# PRODUCT CHANGE NOTIFICATION

Product Category COPPER PATCHCORDS 20210728-2

Product Group ENTERPRISE CONNECTIVITY

ISSUE DATE: 28-Aug-21

Photos/Drawing (where applicable)

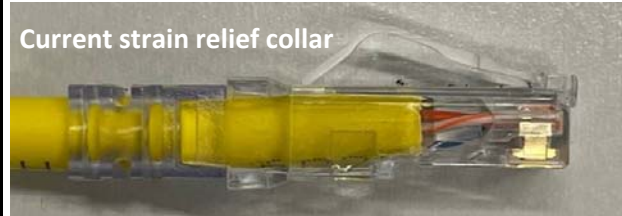
Panduit is making a slight tweak to the strain relief collar of our NK6APC series NetKey Copper Category 6A patchcords. The new strain relief collar provides an improved strain relief and a more seamless transition between the plug and boot. This will be a running change since there is no significant difference to fit or function of the patchcords, and the difference in form is nearly imperceptible. This also means that we will not change the part number at all, so this is more just an informative PCN. Please note that this change does not affect the NKU6APC series patchcords for our Asia Pacific market.
